BWIP REVIEW COMMENT RECORD (RCR)

5. Document Number(s)/Title(s) Expedited special case package; documents supporting restart of
6. Project/Building Number
7. Reviewer Yakima Indian Nation
8. Organization/Group
9. Location/Phone

5. Document Number(s)/Title(s) Expedited special case package; documents supporting restart of DC-24 CX and DC-25 CX		6. Project/Building Number	7. Reviewer Yakima Indian Nation	8. Organization/Group	9. Location/Phone
		10. Agreement with indicated comment disposition(s) 8/14/87 Date Reviewer M.W. Parsons M.W. Parsons Project/Cognizant Engineer		11. CLOSED 8/21/87 Date Reviewer R.P. Saget DOE RL READINESS REVIEW BOARD Project/Cognizant Engineer	
12. Item	13. Comment(s)/Discrepancy(s) (Provide technical justification for the comment and detailed recommendation of the action required to correct/resolve the discrepancy/problem indicated).			14. Disposition (provide justification if NOT accepted).

Response to:
Proposed Restart of Drilling of
DC-23, DC-24, DC-25, DC-32 and
DC-33 for BWIP Hydrology Program

Nez Perce 1

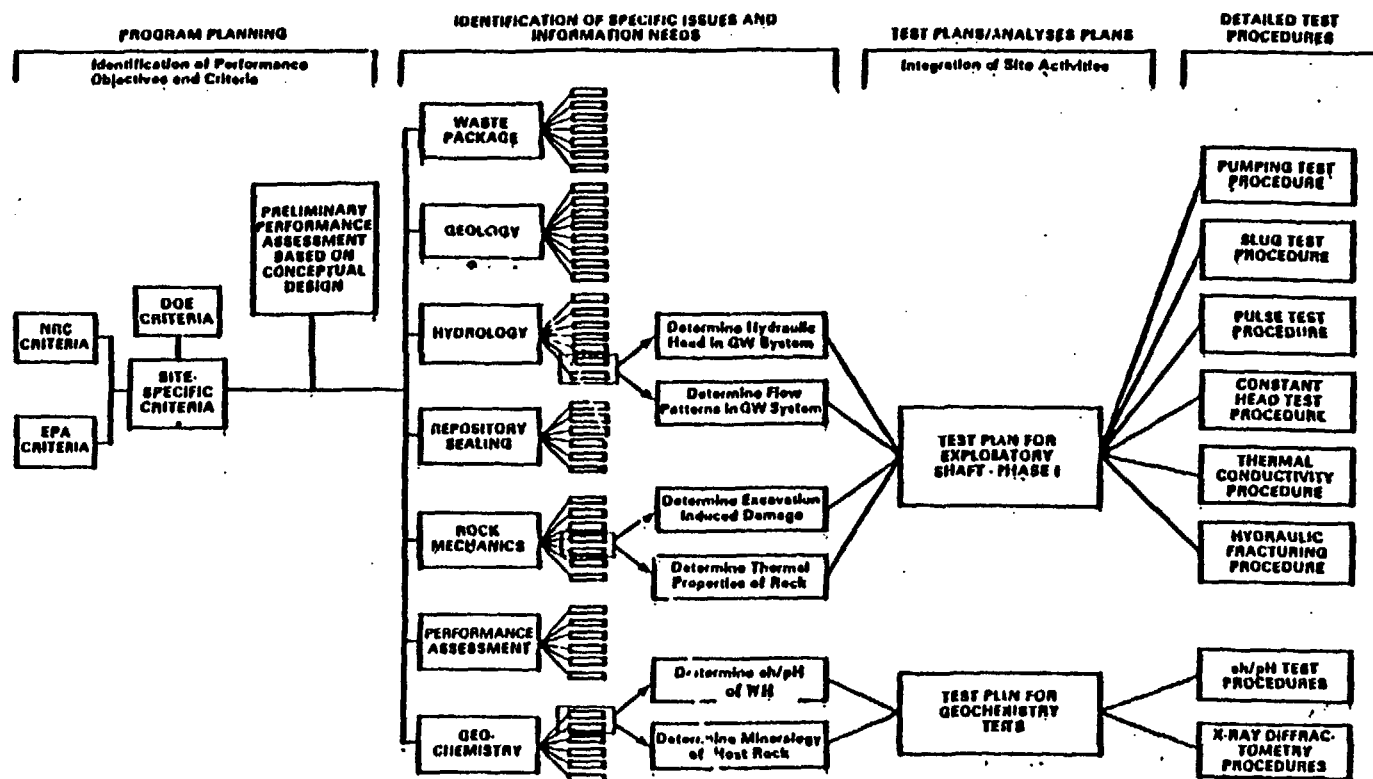
1. The BWIP has quality graded all components related to drilling and piezometer installations as either level 1 or level 3. Quality level 1 is applied to an item or activity in which failure may allow radioactive materials to reach the uncontrolled environment or involves or affects public safety and health. Quality level 3 generally applies industry accepted practices and standard, and sound engineering or scientific practices. The quality level assignments appear to be appropriate to the needs of the data requirements. However, DOE/BWIP assigned quality level 3 to logging of drill cuttings, but quality level 1 to geophysical logging. This would seem to be somewhat inconsistent. The implication here is that if data is machine produced (geophysical data) it is level 1 because it can be reproduced or replicated. Professionally trained personnel would also essentially log drill cuttings the same way. Little bias would be introduced. It seems that the physical description of drilled materials should be weighted equally in the interpretation of lithologic sequences as their geophysical properties. It could be argued that physical lithologic descriptions are more accurate than geophysical logs of the same medium, because lithologic characteristics are inherent in the material, whereas geophysical properties are as much a reflection of borehole and fluid conditions as they are of the inherent character of the geologic material.

Reject.

The determination of QA level is based upon the use of the data, not how the data is produced. Formal stratigraphic interpretations and piezometer placement decisions will be based upon geophysical logging data, and confirmed by drill cutting analyses. QA Level 1 has been designated as applicable to these activities. The geologic logs, consisting of drill-rate and chip descriptive logs for these rotary boreholes, are considered inconclusive by comparison. While they are of value for information purposes during drilling and for initial recognition of stratigraphic contacts, they will not be used for direct interpretations. Therefore QA Level 3 has been applied.
